November 14, 2024

HMC Architects Project No. 3431007

ADDENDUM NO. 02

Lodi Middle School Additions and Modernization – HVAC Replacement

AJ4.11
AD2.03

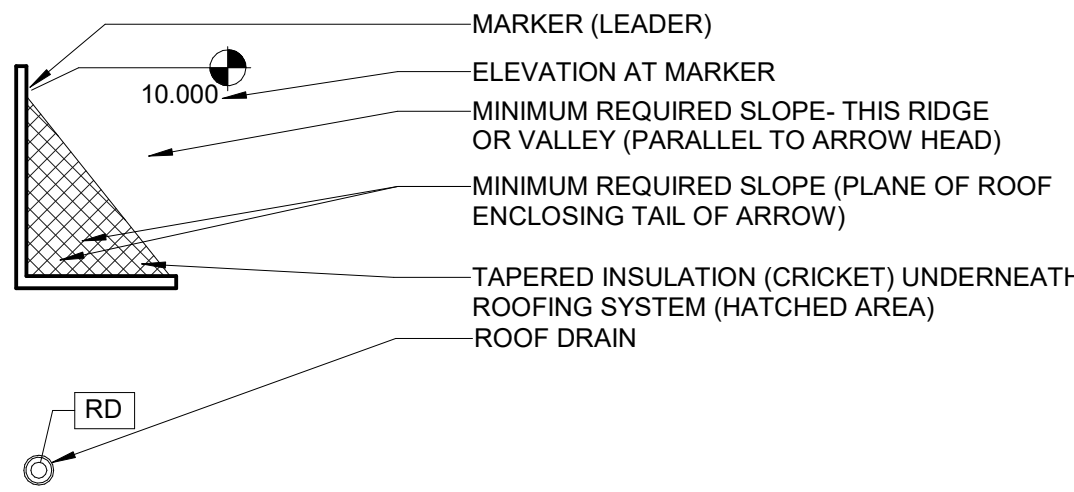
16. If PV system is required for this project, can PV be placed on shade canopies in the parking lot?

A: The PV system shall be located on the roof of Unit J as shown on AJ4.11.
